**Laguna Honda Hospital and  
Rehabilitation Center**

**Rehabilitation Services Department**

**Recommendations:**

*Tree Allee's  
"ADA-Accessible" Ramp*

Figure 6

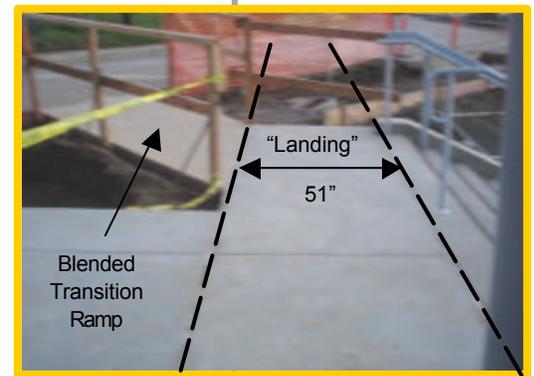
Although construction of the area shown in Figure 6 of the sidewalk is not yet complete, it appears that wheelchair users who use the blended transition to move from the crosswalk crossing West Clarendon Road onto the Tree Allee ramp may not have the required 60" flat landing area clear space in front of the top step of the staircase, as required by paragraph 4.8.4 of the *Pocket Guide to the ADAAG*, since it is only 51" wide.

We recommend placing a detectable warning surface on both ends of the blended transition ramp.

Therefore, we recommend modifying the design to increase the landing at the top of the staircase to 60" wide, shortening the blended transition ramp from West Clarendon Road, as necessary.

**Recommendation 4:**  
 Modify the design specs to increase the landing at the top of the staircase to 60" wide, shortening the blended transition ramp from West Clarendon Road, as necessary.
